BUILDING CODE OF AUSTRALIA COMPLIANCE ASSESSMENT REPORT

MAIN WORKS FOR WATERLOO MIXED USE DEVELOPMENT (HDA) - SSD-80441462

207-229 YOUNG STREET, 881-885 & 887 BOURKE STREET, WATERLOO

REPORT NO. ► 13143.9 – Parcel 1 – Rev.00

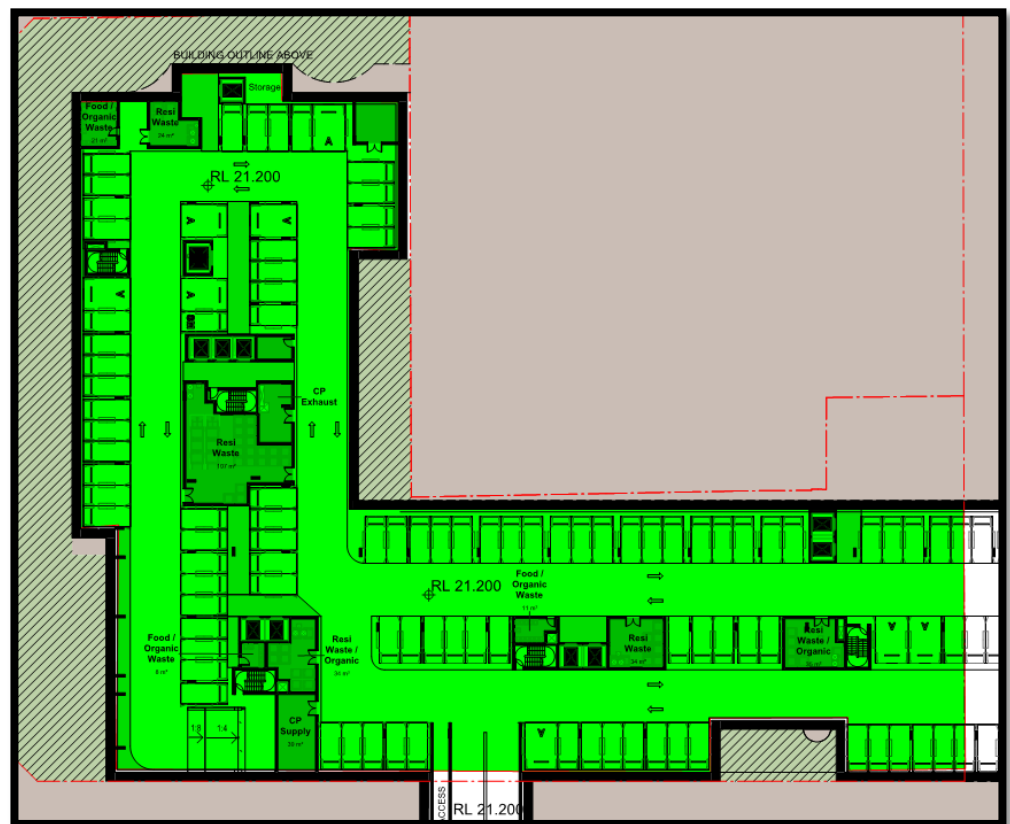
As a result of the above, these walls on both Parcels 1 and 4 have likely not been considered as requiring an FRL, however, technically these do under DTS due to a side boundary passing through the lot. It is recommended this be considered in the Fire Engineering Strategy and easements or a right of way be applied to these boundaries to ensure there is no future buildings placed on these portions of the land. Further Information Required – Slab Set-downs and Cavities - Any cavities provided within the external wall compromising horizontal and vertical fire separation and not fire stopped with a tested system is to be addressed by way of a Performance Solution by the fire engineer at CC stage. - Junction details to be provided at CC stage. - The fire engineer is to address by way of a Performance Solution at CC stage set-downs proposed within internal wet areas reducing the thickness of the slab and FRL achieved by the slab.	Distance from a fire-source feature	FRL (in minutes): Structural adequacy / Integrity / Insulation				Class 2, 3 or 4 part	Class 5, 7a or 9	Class 6	Class 7b or 8	Less than 1.5 m	-/90/90	-/120/120	-/180/180	-/240/240	1.5 to less than 3 m	-/60/60	-/90/90	-/180/120	-/240/180	3 m or more	-/-/-	-/-/-	-/-/-	-/-/-
Distance from a fire-source feature	FRL (in minutes): Structural adequacy / Integrity / Insulation																								
	Class 2, 3 or 4 part	Class 5, 7a or 9	Class 6	Class 7b or 8																					
Less than 1.5 m	-/90/90	-/120/120	-/180/180	-/240/240																					
1.5 to less than 3 m	-/60/60	-/90/90	-/180/120	-/240/180																					
3 m or more	-/-/-	-/-/-	-/-/-	-/-/-																					
C2D10 Non-Combustible Elements	Further Information Required – External Wall Test Reports External Walls on a structure of Type A Construction (applicable to this building) are required to be non-combustible when tested in accordance with AS1530.1. No specifications or testing reports have been provided for the external walls of this building at this stage, and as such further information is required to determine compliance. It is recommended that this documentation be supplied to AED and the Principal Certifier to determine compliance with C2D10 at the Construction Certificate stage.																								
C3D8 Fire Walls	DTS Departure – Separation by Fire Walls Different buildings are required to be separated by fire walls in accordance with this part. Currently, all buildings are connected as a United Building. This means it should be assessed as a single building as opposed to multiple buildings.  AED recommend separation by fire walls and fire doors to ensure the buildings can be considered separate. Alternatively, new plans are to be assessed with the combined as fire source features and travel distances will drastically change.																								
C3D9 Separation of Classifications in the Same Storey	Compliance Required – Separation of Classifications Each classification is required to be separated within each storey by construction comply with that in Tables SC11a-SC11g of Specification 5. Should compliance not be achieved through a DTS compliant amendment to the plans, then a Performance-Based Fire Engineered Solution is required to be obtained.

Basement 2

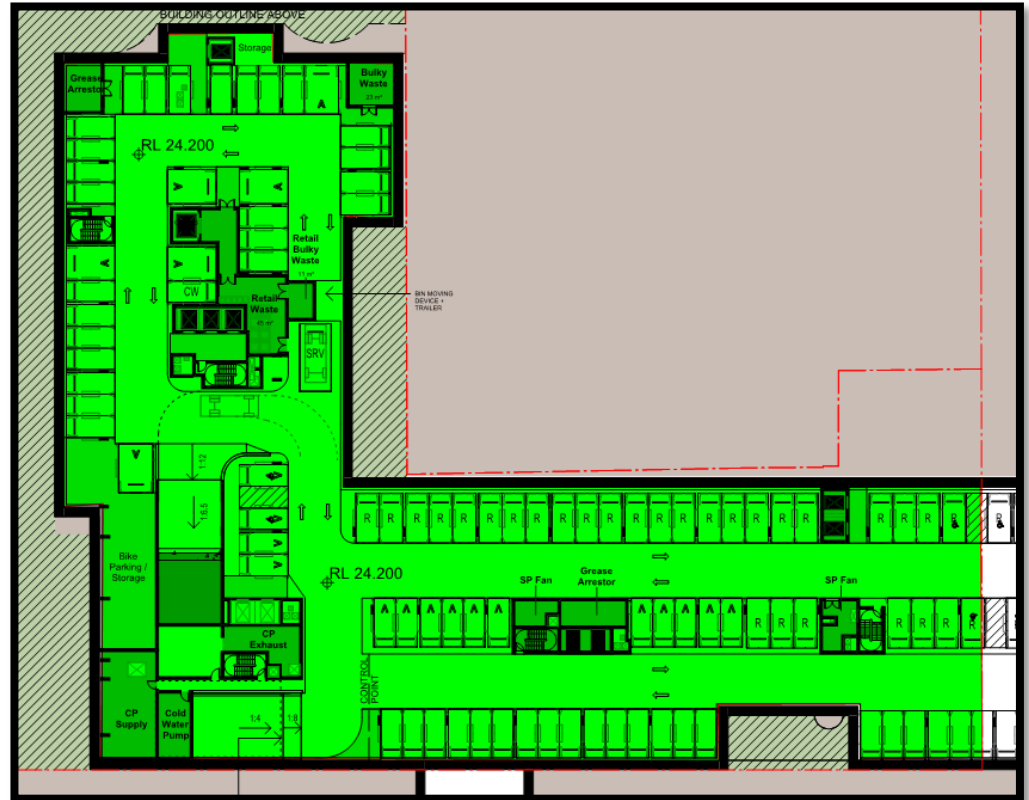
The following assessment of each main area is established based on the overall areas of each classification.

Classification	FRL
Class 2	90/90/90
Class 5	120/120/120
Class 6	180/180/180
Class 7a	120/120/120
Class 7b	240/240/240
Class 9b	120/120/120

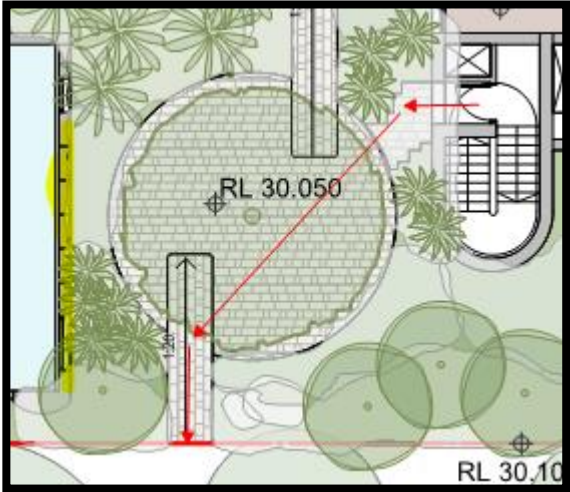
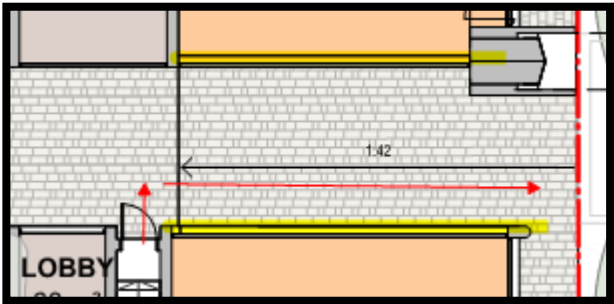
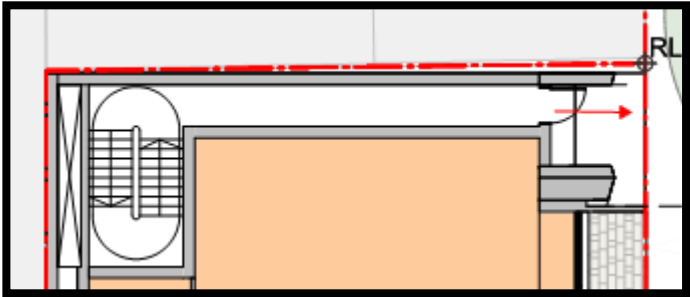
BCA Clause	Deemed-to-Satisfy Provision to be addressed
	 Confirmation is required to be supplied to detail the locations of lot boundaries through the provision of a Deposited Plan to be supplied on application for a Construction Certificate. Alternatively, the DA will stipulate any lot subdivision or consolidation. Once this has been confirmed, the extent of the FER will be required to be addressed.
C4D4 Separation of external walls and associated openings in different fire compartments [2019: C3.3]	Further Information Required – Openings in Different Fire Compartments Openings in external walls to different fire compartments separated by a fire wall are to be protected in accordance with this clause or addressed by way of a Performance Solution by the fire engineer at CC stage. Examples of openings to comply with the clause are clouded below:

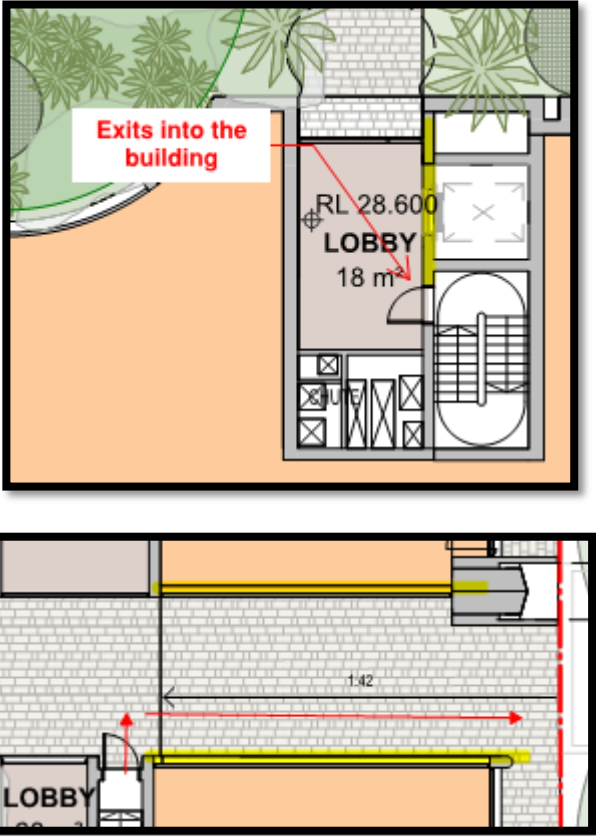
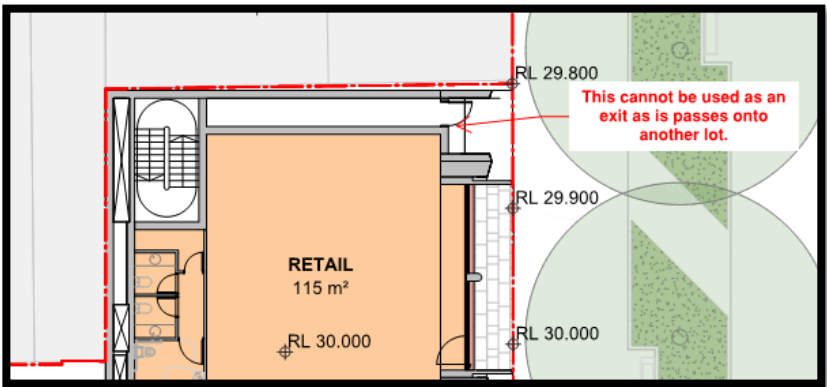
Further specifications are required to be supplied to confirm compliance. DTS Departure – Bounding Construction The Studio Suites have window openings directly to the corridor which does not comply with this clause. As such, this is required to be addressed through a fire engineered solution: 	Table S5C11f: Type A construction: FRL of non-loadbearing internal walls					Location	FRL (in minutes): <i>Structural adequacy / Integrity / Insulation</i>				Class 2, 3 or 4 part	Class 5, 7a or 9	Class 6	Class 7b or 8	Fire-resisting lift and stair shafts	-/90/90	-/120/120	-120/120	-/120/120	Bounding public corridors, public lobbies and the like	-/60/60	-/-/-	-/-/-	-/-/-	Between or bounding sole-occupancy units	-/60/60	-/-/-	-/-/-	-/-/-	Ventilating, pipe, garbage, and like shafts not used for the discharge of hot products of combustion	-/90/90	-/90/90	-/120/120	-/120/120
Table S5C11f: Type A construction: FRL of non-loadbearing internal walls																																			
Location	FRL (in minutes): <i>Structural adequacy / Integrity / Insulation</i>																																		
	Class 2, 3 or 4 part	Class 5, 7a or 9	Class 6	Class 7b or 8																															
Fire-resisting lift and stair shafts	-/90/90	-/120/120	-120/120	-/120/120																															
Bounding public corridors, public lobbies and the like	-/60/60	-/-/-	-/-/-	-/-/-																															
Between or bounding sole-occupancy units	-/60/60	-/-/-	-/-/-	-/-/-																															
Ventilating, pipe, garbage, and like shafts not used for the discharge of hot products of combustion	-/90/90	-/90/90	-/120/120	-/120/120																															
C4D14 Openings for Shafts	Further Information Required – Shaft Construction or Penetrations Sealed in accordance with AS1530.4

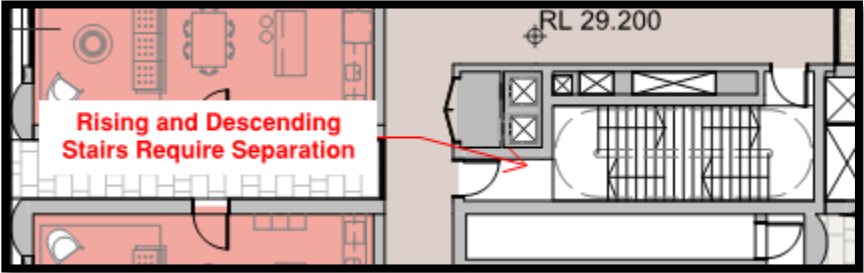
BCA Clause	Deemed-to-Satisfy Provision to be addressed
	Confirmation is required to be supplied to confirm the construction methods for what appears to be shafts and the openings applicable at doorways for those shafts:  Full specifications and testing reports are required to be supplied to detail the shaft construction for the garbage chutes, hydraulic shafts, mechanical shafts, and electrical shafts as applicable. In addition, this is required to be supplied for the construction of any doorways for service cupboards, or confirmation if they are being sealed at the floors and walls in accordance with a tested system to AS1530.4.
D2D3 Number of Exits Required	DTS Departure – Number of Exits Multiple portions of the building are not showing doors. For example, the ground floor (see the following):  DTS Departure – Less than 2 Exits to Parts of the Building Under D2D3 (7), all parts of the building require access to at least 2 exits. Currently, there are parts of the building that provide access to only one exit:  As such, this should either be addressed through a re-design, or a fire engineered solution. Also confirm how you exit/access this plant room:

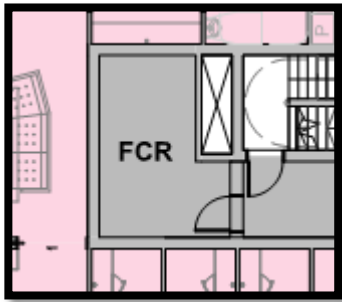
D2D5 Exit Travel Distances	DTS Departure – Travel Distances (Residential Corridors) The travel distances in common area corridors exceed 6m (12m with the concession). The common corridors in residential areas are approx 14m to a point of choice between the two exits.  As a result of the above, this is required to be addressed through a performance-based fire engineered solution. A detailed measurement will be required and provided once construction drawings are prepared. DTS Departure – Basement Distance to a point of choice (Basement 1) The basement travel distance when scaled exceeds 20m to a point of choice (34m at worst case). See the following examples:

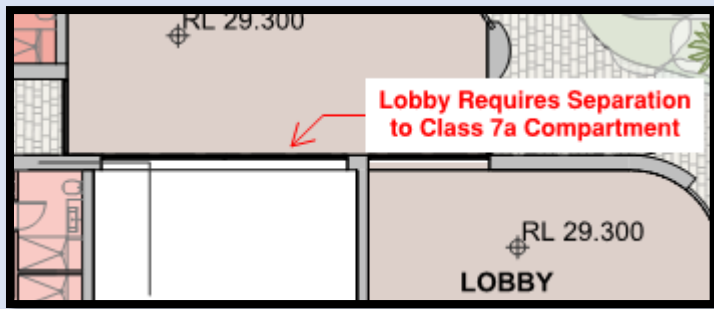
BCA DEEMED-TO-SATISFY PROVISION	COMPLIES	DOES NOT COMPLY	NA or Informational	Compliance Required	COMMENTS
					(b) Any openings in a fire wall must not reduce the FRL required by Specification 5 for the fire wall, except where permitted by the Deemed-to-Satisfy Provisions of Part C4. (c) Building elements, other than roof battens with dimensions of 75 mm x 50 mm or less or sarking- type material, must not pass through or cross the fire wall unless the required fire-resisting performance of the fire wall is maintained. (2) Separation of buildings — A part of a building separated from the remainder of the building by a fire wall may be treated as a separate building for the purposes of the Deemed-to-Satisfy Provisions of Sections C, D and E if it is constructed in accordance with (1) and the following: (a) The fire wall extends through all storeys and spaces in the nature of storeys that are common to that part and any adjoining part of the building. (b) The fire wall is carried through to the underside of the roof covering. (c) Where the roof of one of the adjoining parts is lower than the roof of the other part, the fire wall extends to the underside of— (i) the covering of the higher roof, or not less than 6 m above the covering of the lower roof; or (ii) the lower roof if it has an FRL not less than that of the fire wall and no openings closer than 3m to any wall above the lower roof; or (iii) the lower roof if its covering is non-combustible and the lower part has a sprinkler system (other than a FPAA101D or FPAA101H system) complying with Specification 17. (3) Separation of fire compartments — A part of a building separated from the remainder of the building by a fire wall may be treated as a separate fire compartment if it is constructed in accordance with (a) and the fire wall extends to the underside of— (a) a floor having an FRL required for a fire wall; or (b) the roof covering. DTS Departure – Separation by Fire Walls Different buildings are required to be separated by fire walls in accordance with this part. Currently, all buildings are connected as a United Building. This means it should be assessed as a single building as opposed to multiple buildings.  AED recommend separation by fire walls and fire doors to ensure the buildings can be considered separate. Alternatively, new plans are to be assessed with the combined as fire source features and travel distances will drastically change.

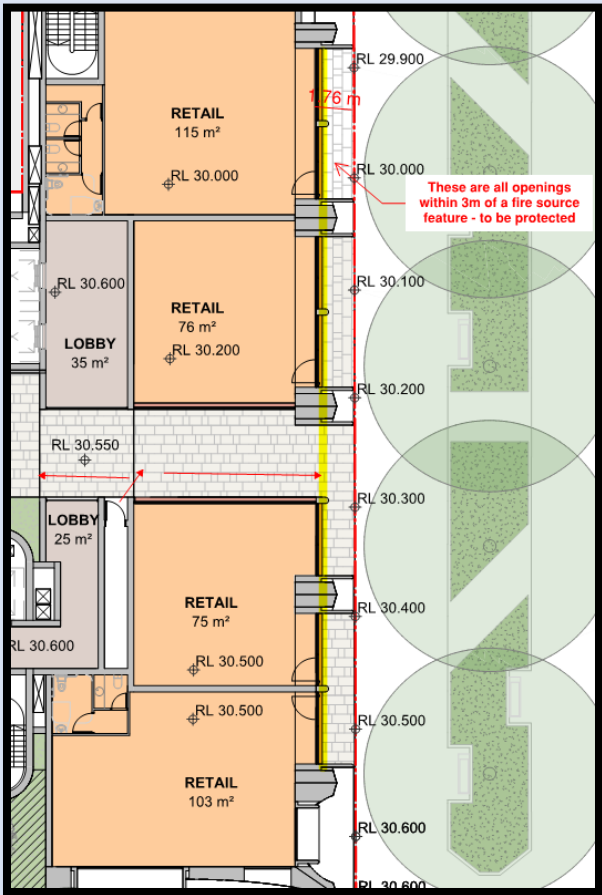
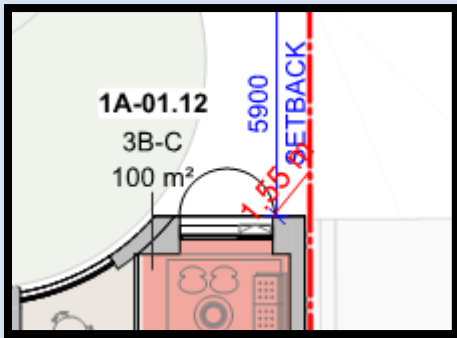
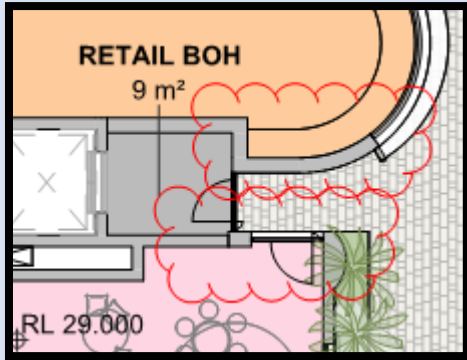
C3D14 Electricity supply system [2019: C2.13]				X	(1) An electricity substation located within a building must— (a) be separated from any other part of the building by construction having an FRL of not less than 120/120/120; and (b) have any doorway in that construction protected with a self-closing fire door having an FRL of not less than – /120/30.

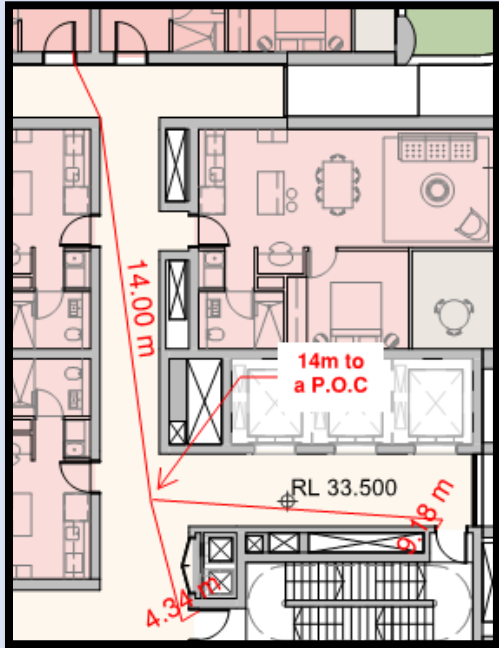
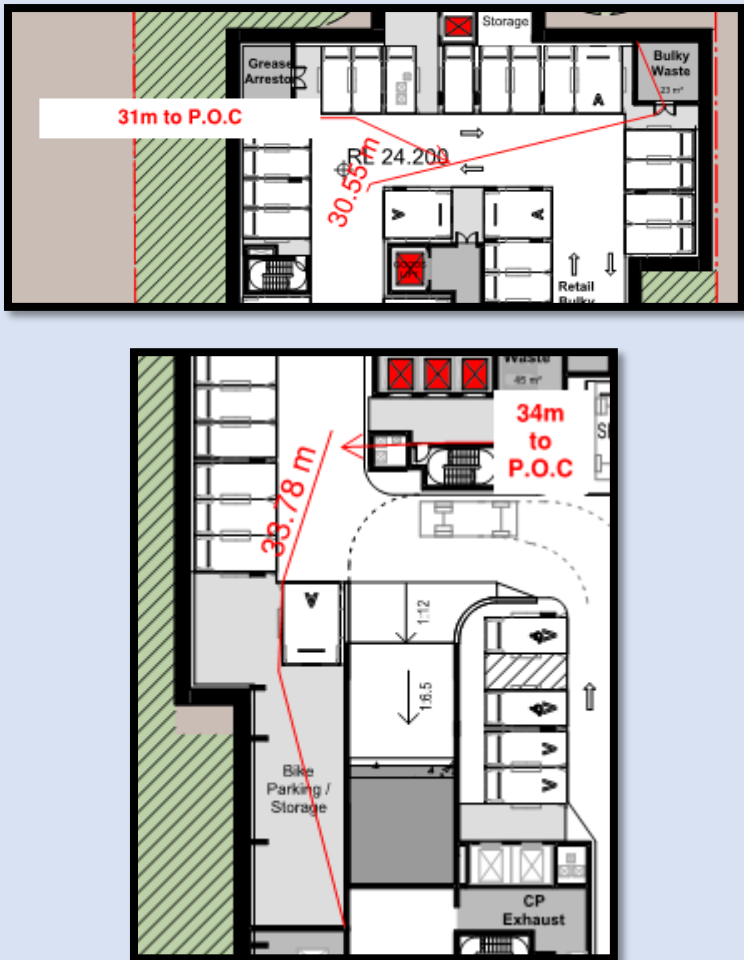
BCA DEEMED-TO-SATISFY PROVISION	COMPLIES	DOES NOT COMPLY	NA or Informational	Compliance Required	COMMENTS
NSW D2D3 Number of exits required [2019: D1.2]		X			(1) All buildings — Every building must have at least one exit from each storey. (2) Class 2 to 8 buildings — (a) In addition to any horizontal exit, not less than 2 exits must be provided from the following: (i) Each storey if the building has an effective height of more than 25 m. (ii) A Class 2 or 3 building subject to C2D6. (b) The requirements of (a)(i) do not apply to a part of a storey that— (i) is provided with direct egress to a road or open space; and (ii) satisfies D2D5 by the provision of 1 exit. (3) Basements — In addition to any horizontal exit, not less than 2 exits must be provided from any storey if egress from that storey involves a vertical rise within the building of more than 1.5 m, unless— (a) the floor area of the storey is not more than 50 m²; and (b) the distance of travel from any point on the floor to a single exit is not more than 20 m. (4) Class 9 buildings — (a) In addition to any horizontal exit, not less than 2 exits must be provided from the following: (i) Each storey if the building has a rise in storeys of more than 6 or an effective height of more than 25 m. (vi) Any storey or mezzanine that accommodates more than 50 persons, calculated under D2D18. (vii) Any storey or mezzanine within an auditorium in an entertainment venue. (b) The requirements of (a) do not apply to a part of a storey that— (i) is a plant room, machinery room, storeroom, lift-machine room or the like; and (ii) is provided with direct egress to a road, open space or a fire-isolated exit complying with D2D12(2); and (iii) satisfies D2D5 by the provision of 1 exit. (7) Access to exits — Without passing through another sole-occupancy unit every occupant of a storey or part of a storey must have access to— (a) an exit; or (b) at least 2 exits if 2 or more exits are required. DTS Departure – Number of Exits Multiple portions of the building are not showing doors. For example, the ground floor (see the following):

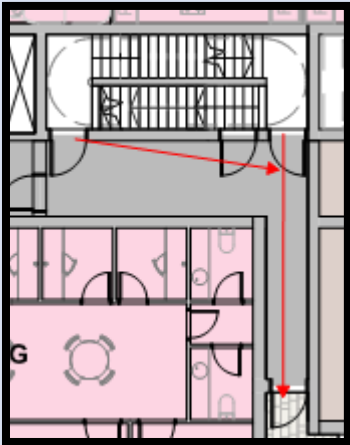
D2D6 Distance between alternative exits [2019: D1.5]		X			Exits that are required as alternative means of egress must be— (a) distributed as uniformly as practicable within or around the storey served and in positions where unobstructed access to at least 2 exits is readily available from all points on the floor including lift lobby areas; and (b) not less than 9 m apart; and (c) not more than— (i) in a Class 2 or 3 building — 45 m apart; or (iii) in all other cases — 60 m apart; and (d) located so that alternative paths of travel do not converge such that they become less than 6m apart. DTS Departure – Alternative Exits less than 9m Alternative exits are required to be no less than 9m apart. Multiple storeys contain exits too close together. See the following example:

BCA DEEMED-TO-SATISFY PROVISION	COMPLIES	DOES NOT COMPLY	NA or Informational	Compliance Required	COMMENTS
					 As such, this is required to be addressed through a fire engineered solution.
D2D7 Height of doorways in exits and paths of travel to exits [2019: D1.6(a)]				X	In a required exit or path of travel to an exit the unobstructed height throughout must be not less than 2 m, except the unobstructed height of any doorway may be reduced to not less than 1980 mm. Details demonstrating compliance with this clause must be incorporated into the construction certificate plans / specification
NSW D2D8 Width of exits and paths of travel to exits [2019: D1.6(b), (c), (d) and (e)]				X	(1) The unobstructed width of each required exit or path of travel to an exit, except for ladders provided in accordance with D2D21, D3D23 or I3D5, and doorways, must be not less than— (a) 1 m; or (b) 1.8 m in a passageway, corridor or ramp normally used for the transportation of patients in beds within a treatment area or ward area; and (c) in a public corridor in a Class 9c aged care building, notwithstanding (2) and (3)— (i) 1.5 m; and (ii) 1.8 m for the full width of the doorway, providing access into a sole-occupancy unit or communal bathroom. (2) If the storey, mezzanine or open spectator stand accommodates more than 100 persons but not more than 200 persons, the aggregate unobstructed width of each required exit or path of travel to an exit, except for doorways, must be not less than— (a) 1 m plus 250 mm for each 25 persons (or part) in excess of 100; or (b) 1.8 m in a passageway, corridor or ramp normally used for the transportation of patients in beds within a treatment area or ward area. (3) If the storey, mezzanine or open spectator stand accommodates more than 200 persons, the aggregate unobstructed width of each required exit or path of travel to an exit, except for doorways, must be not less than— (a) 2 m plus 500 mm for every 60 persons (or part) in excess of 200 persons if egress involves a change in floor level by a stairway or ramp with a gradient steeper than 1 in 12; or (b) in any other case, 2 m plus 500 mm for every 75 persons (or part) in excess of 200. (4) In an open spectator stand which accommodates more than 2000 persons, the aggregate unobstructed width of each required exit or path of travel to an exit, except for doorways, must be not less than 17 m plus a width (in metres) equal to the number in excess of 2000 divided by 600.

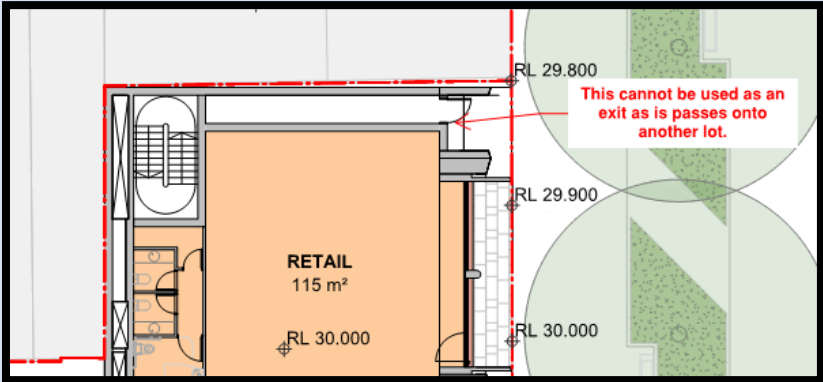
BCA DEEMED-TO-SATISFY PROVISION	COMPLIES	DOES NOT COMPLY	NA or Informational	Compliance Required	COMMENTS
					 The diagram is a detailed floor plan of a building section. It includes several rooms: a pink-shaded 'MUSIC' room (49 m²) at the top left; a large brown-shaded 'LOBBY' (143 m²) below it; another brown-shaded 'LOBBY' (55 m²) to the right of the first lobby; a pink-shaded 'BIKE STORE' (45 m²) at the bottom; and a small 'BOOSTER' area at the very bottom. Red arrows point from the 'COMMENTS' column to specific features: one points to a curved wall in the top lobby, another to a wall in the middle lobby, a third to a wall near the bike store, and a fourth to a wall near the booster. Elevation markers (RL) are present: 29.300, 28.350, 28.700, and 28.180. The plan also shows stairs, doors, and some outdoor landscaping like trees and a paved area.
